Service Bulletin

Bulletin No.: 22-NA-187

Subject: Information on Service 4WD Light Intermittently Displays On the Drivers Information Center (DIC) and Will Not Engage when Selecting 4WD - DTC C11B9, C05FB, C15C1, C15AB, U0422-71 and/or U0401-71 Set

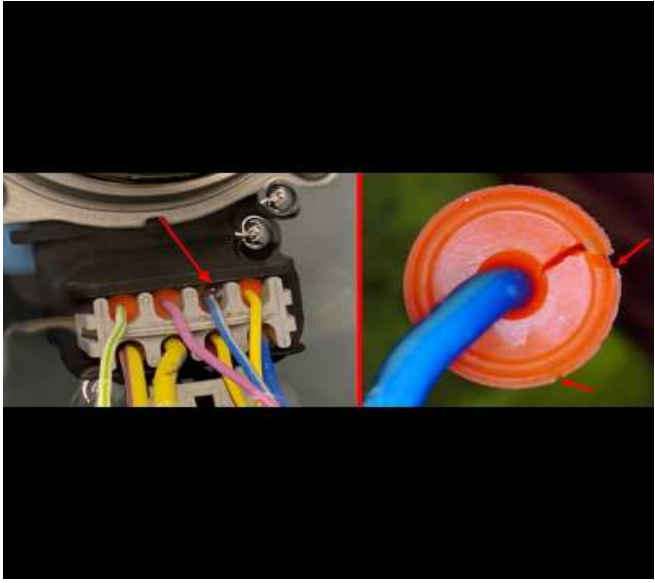
Involved Region or Country	North America
Condition	<p>Some customers may comment that the Service four-wheel drive light will intermittently display on the DIC and will not engage when selecting four-wheel drive.</p> <p>Some technicians may find one or more DTC set:</p> <ul style="list-style-type: none"> • C11B9 • C05FB • C15C1 • C15AB • U0422-71 • U0401-71
Cause	<p>This condition may be caused by potential water intrusion at the Transfer Case Actuator connector on the harness side.</p> <p>– The grommet may be cracked or torn.</p>
Information	<div style="text-align: center;">  </div> <p style="text-align: right; margin-right: 20px;">6151017</p> <p>Inspect the transfer case electrical connector and the transfer case connector on the actuator motor for signs of corrosion. This may indicate that a grommet in said connector may be damaged as shown in the graphic above.</p> <p>– If there are signs of corrosion or damage to the grommet, replace the electrical connector and refer to SI for repair.</p>

Refer to *Wire to Wire Repair in SI* and *Repairing Connector Terminals in SI*.
